**LEE'S SUMMIT**  
**MISSOURI**  
Development Services Department

## Development Services Staff Report

<b>File Number</b>	PL2024-283
<b>File Name</b>	REZONING from AG to CP-2 and PRELIMINARY DEVELOPMENT PLAN – View High Sports Complex
<b>Applicant</b>	Engineering Solutions, LLC
<b>Property Address</b>	3350 NW Ashurst Dr.
<b>Planning Commission Date</b>	January 23, 2025
<b>Heard by</b>	Planning Commission and City Council
<b>Analyst</b>	Adair Bright, AICP, Senior Planner

Figure 5 – South elevation facing single-family residential

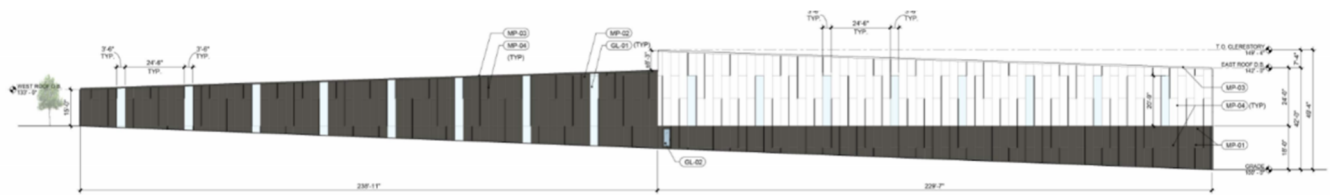
- The applicant has requested a modification to UDO Sec. 8.170.A – Building materials for office, commercial/retail, and industrial buildings.
  - **Requirement** – Metal may not exceed 40% of any façade. A modification for the use of metal up to 75% of any façade may be approved by the Planning Commission. A modification for the use of metal to exceed 75% of any façade may be approved by the Governing Body.

- **Proposed** – The applicant is proposing the following percentages be architectural metal:
    - i. 75% of the north façade
    - ii. 92% of the south façade

- iii. 86% of the east façade
    - iv. 67% of the west façade
  - **Recommendation** – Staff is supportive of the requested modification. The facades containing the highest amount of metal are to the south and east and those sides will be buffered by existing vegetation along with new evergreens. The request is consistent with other approved developments in the City such as churches, car dealerships, and the recently approved Fire Stations.

Figure 8 – Proposed landscape plan (green hatched area denotes tree preservation in lieu of six-foot tall fence of three-foot tall berm)

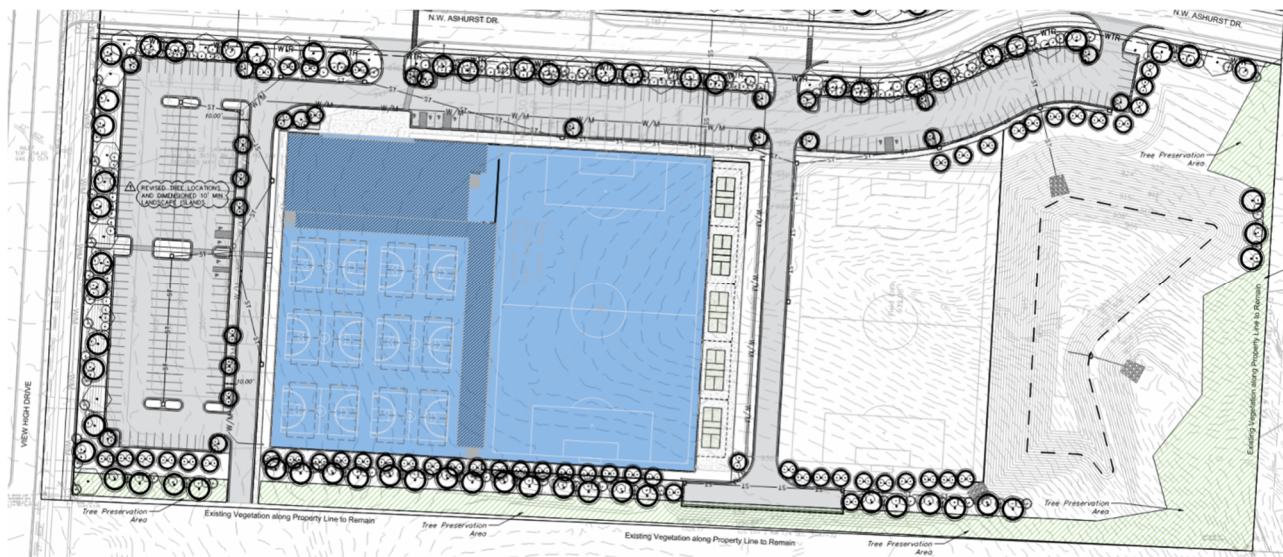
- The applicant has requested a modification to UDO Sec. 8.900.A – High Impact Screening.

- **Requirement** – A 100 percent opaque screen between land uses, which are dissimilar in character. When the proposed plan is considered to have a high impact on surrounding properties or the adjacent property is considered to have an adverse impact, both of the following shall be installed within the 20-foot buffer yard: (1) a six-foot high masonry wall, opaque vinyl fence, or three-foot high berm, (2) and low impact screening.
- **Proposed** – The applicant is proposing to preserve the existing mature vegetation and install evergreens in lieu of installing a six-foot high masonry wall, opaque vinyl fence, or three-foot high berm within the southern and eastern buffer yards.
- **Recommendation** – Staff is supportive of the proposed modification as we feel the mature existing vegetation will provide a better visual and spatial buffer than could be achieved with a fence.

1. Development shall be in accordance with the preliminary development plan with an upload date of January 3, 2025.
2. A modification shall be granted to UDO Sec. 8.170.A to allow for architectural metal panels on more than 40% of all facades as depicted on the plan set uploaded on January 3, 2025.
3. A modification shall be granted to UDO Sec. 8.900.A to waive the requirement for a six-foot high masonry wall, opaque vinyl fence, or three-foot high berm within the southern and eastern buffer yards.
4. A copy of the Shared Parking Agreement shall be provided to staff prior to approval of the Final
